**LOCAL HISTORIC DISTRICT:** Dilworth

**PROPERTY ADDRESS:** 712 East Tremont Avenue

**SUMMARY OF REQUEST:** Window + Front Steps

**APPLICANT/OWNER:** Frank and Tarabeth Hostetter

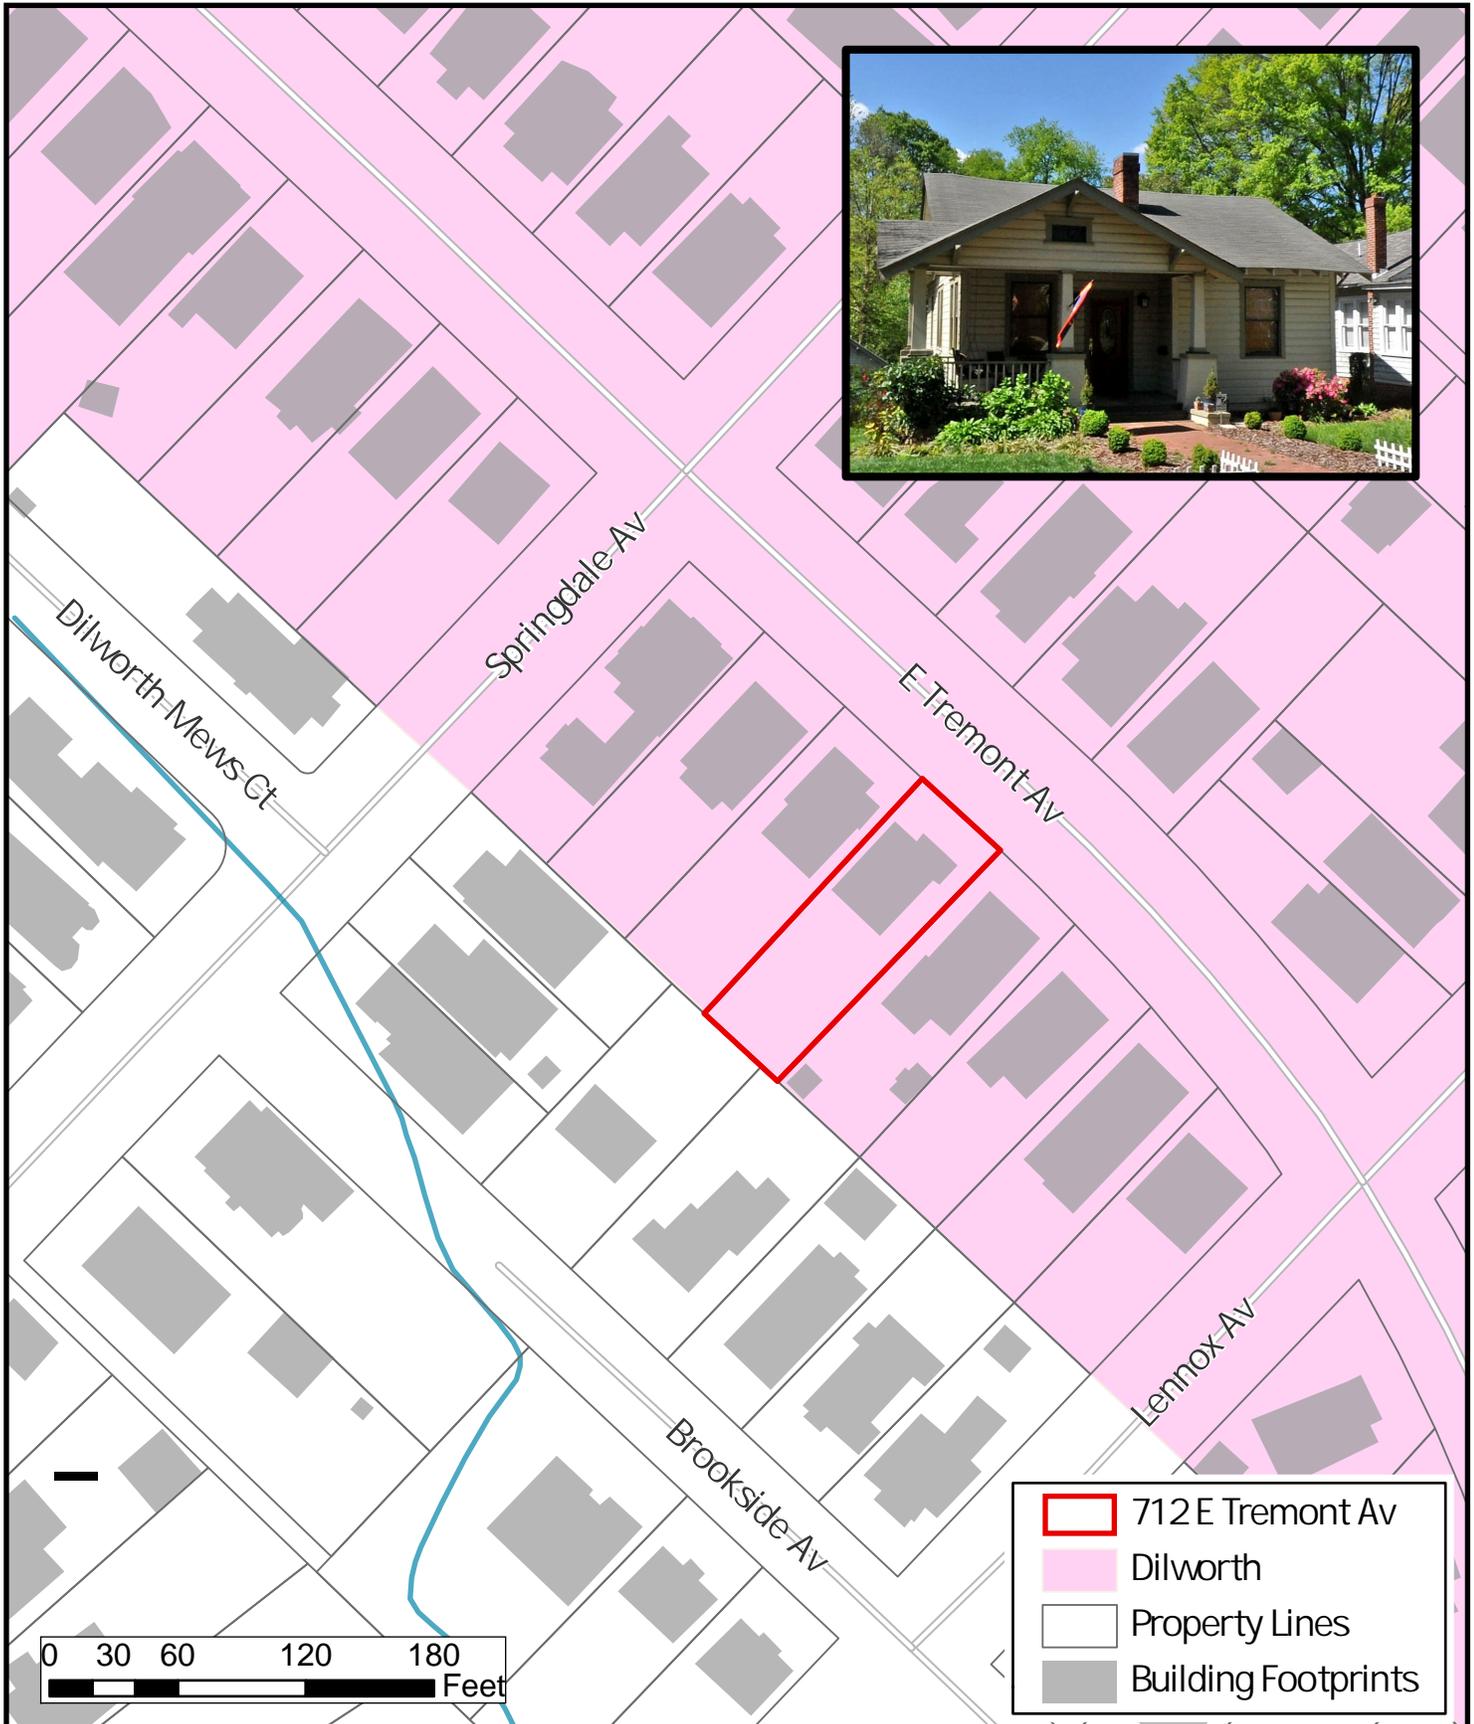
The proposal is a new window opening on the bump-out on the left elevation. The window opening faces the street. The new window will match existing, header height, size, configuration, materials. The proposal is to change existing wood front steps to brick due to flooding issues.

1. The project is not incongruous with the district, brick steps are common on bungalows throughout Dilworth, and the new window meets guidelines Doors and Windows, page 6.12.
2. Staff Recommends full approval for meeting all the Guidelines, per 10.4.1 of the Rules for Procedure.
3. If requested by a Commission member, or if an interested party has signed up to speak in opposition, then the HDC shall open the application for a full hearing.

PROPOSED  
CHANGE:  
add one window  
on bay, facing  
street – custom size  
to match existing  
adjacent windows,  
centered on wall

FRONT STEP  
(1 RISER, 2 TREADS)  
EXISTING CONDITION:  
the front yards of this  
and adjacent  
properties on both  
sides flood \*into\* the  
front stairs – as a  
result this wood step  
is replaced annually  
due to rot

PROPOSED CHANGE:  
replace with  
standard rowlock  
brick as shown in  
photo to the right to  
protect foundation  
from drainage  
conditions
